City of Brisbane
Subcommittee Report

SUBJECT: Ordinance No. 576 (Zoning Text Amendment RZ-5-11) to Amend Brisbane Municipal Code Title 17 Regarding Garage/Carport Minimum Setbacks and Height Limits in the R Residential Districts, Off-Street Parking Regulations, and Alteration/Expansion of Nonconforming Structures

DATE: For January 16, 2014 Planning Issues Subcommittee Meeting

FIGURE VI-C	PROPOSED TRANSPORTATION & CIRCULATION IMPROVEMENTS	Source: TR-2

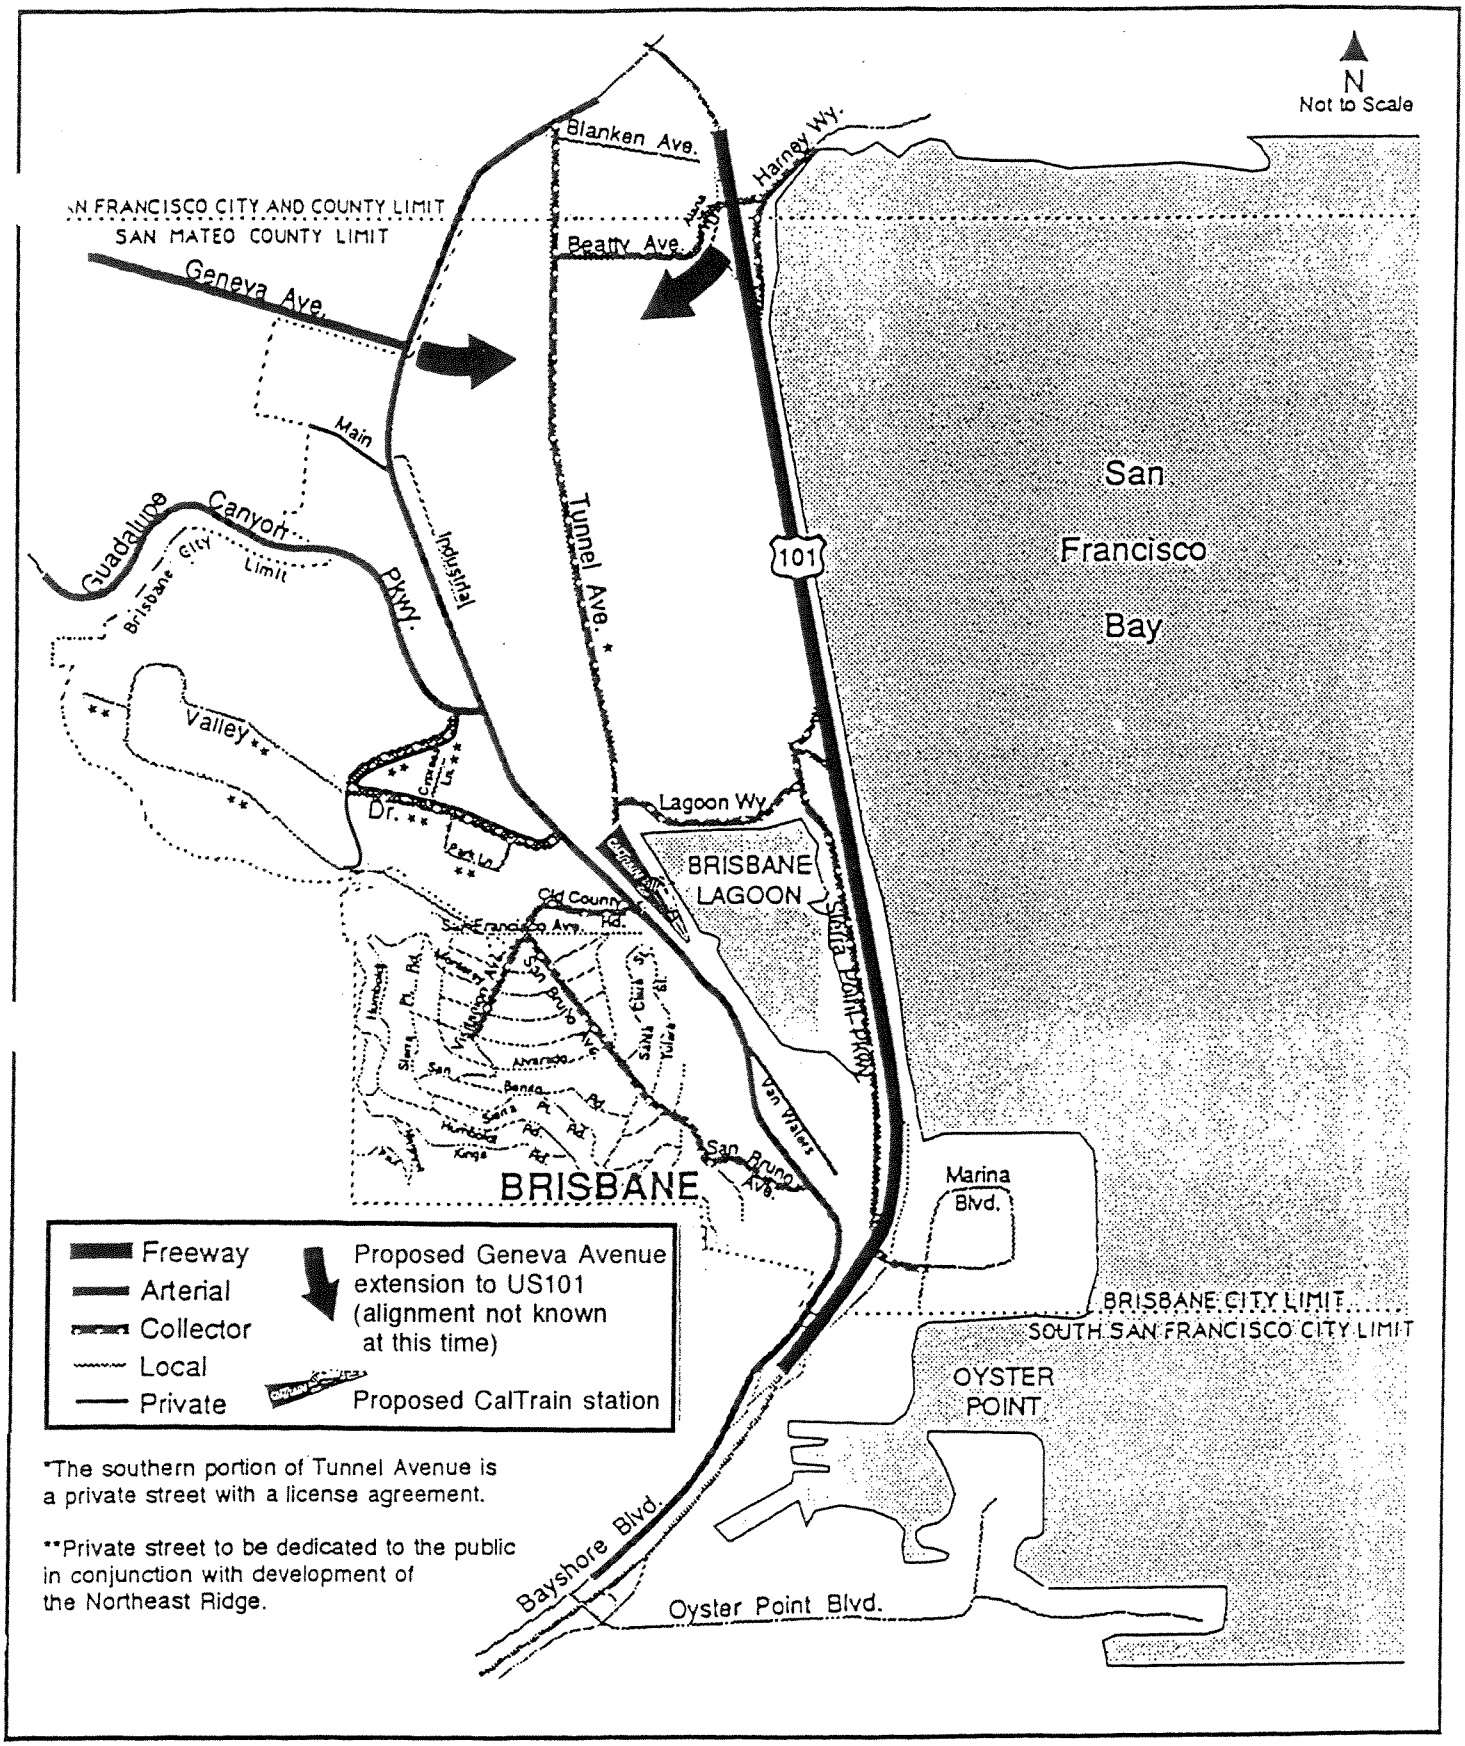
5. Regarding the new requirements for on-site turnaround capacity (Section 17.34.040.I), the parking for buildings with 3 or more units should be designed so cars would not back into the lower part of Visitacion Avenue and Old County Road, with an exemption for existing buildings.

5. Regarding the new requirements for on-site turnaround capacity (Section 17.34.040.I), the parking for buildings with 3 or more units should be designed so cars would not back into the lower part of Visitacion Avenue and Old County Road, with an exemption for existing buildings.

According to the attached, Visitacion Avenue (within the NCRO-2 District) and Old County Road are designated as collector streets, so on-site turnaround capability would be required. It might be clearer to revise Section 17.34.040.I to identify those situations in which on-site turnaround capability is required, rather than specify the exceptions. Existing buildings would be exempt from this requirement per Section 17.34.050.A, which could be cross-referenced in this section.

According to the attached figure form the General Plan Background Report, Visitacion Avenue (within the NCRO-2 District) and Old County Road are designated as collector streets, so on-site turnaround capability would be required. It might be clearer to revise Section 17.34.040.I to identify those situations in which on-site turnaround capability is required, rather than specify the exceptions. Existing buildings would be exempt from
